# IFSAR Quality Assessment Report

## AK\_IFSAR-DEM5-Lot6\_2012

NGTOC  
2013-06-24  
Hannah Boggs

Figure 2 – Checkpoints displayed by slope.

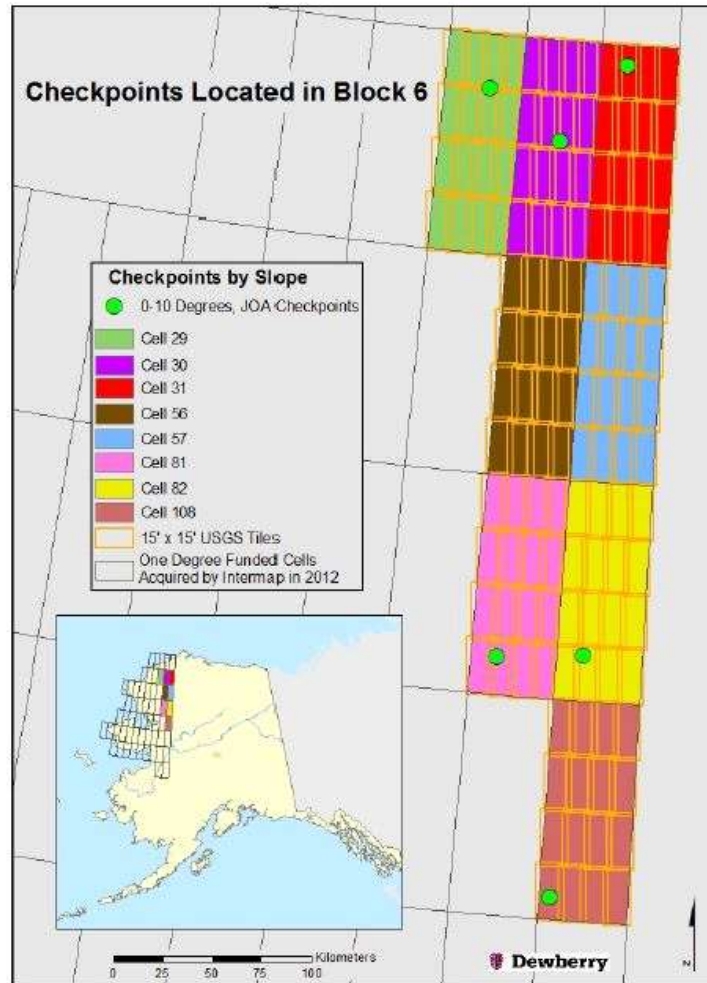
The number of checkpoints delivered to the NGTOC is too few to be considered "well distributed". Additionally, the number of checkpoints is too few to meaningfully test/report vertical accuracy by cell. For Lot 6, vertical accuracy will ONLY be tested using the entire delivery Lot. The RMSE for the entire delivery lot will be used to determine the maximum allowed vertical offset. Accuracy meets specification, accepted.

Based on this review, the USGS accepts the vertical accuracy.
